### **REMARKS**

Claims 1-10 are pending in the present Application.

FIG.1

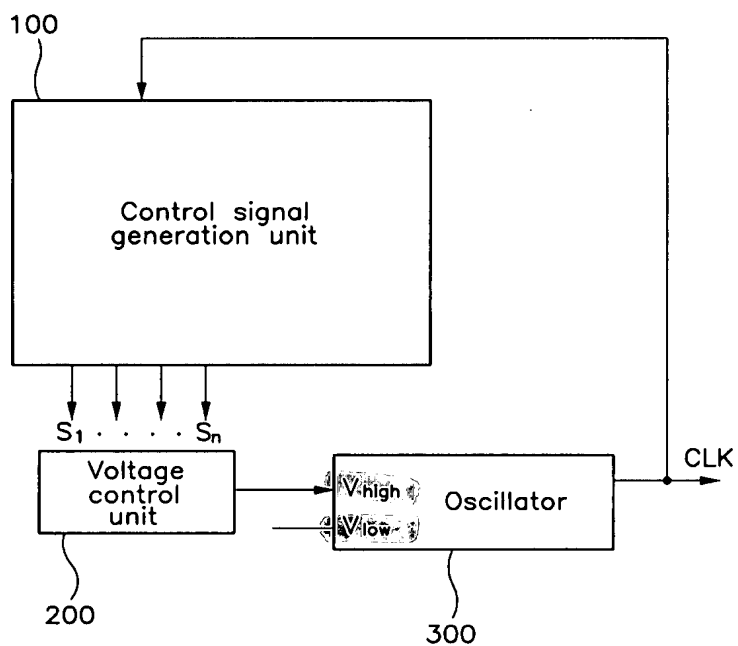
The Examiner objected the drawings. In FIG. 1 the Examiner objected the labeling “V<sub>high</sub>” and “V<sub>low</sub>”. The Examiner suggested the labeling V<sub>high</sub> and V<sub>low</sub>.

In response, Applicant introduced the suggested labeling in amended FIG. 1.
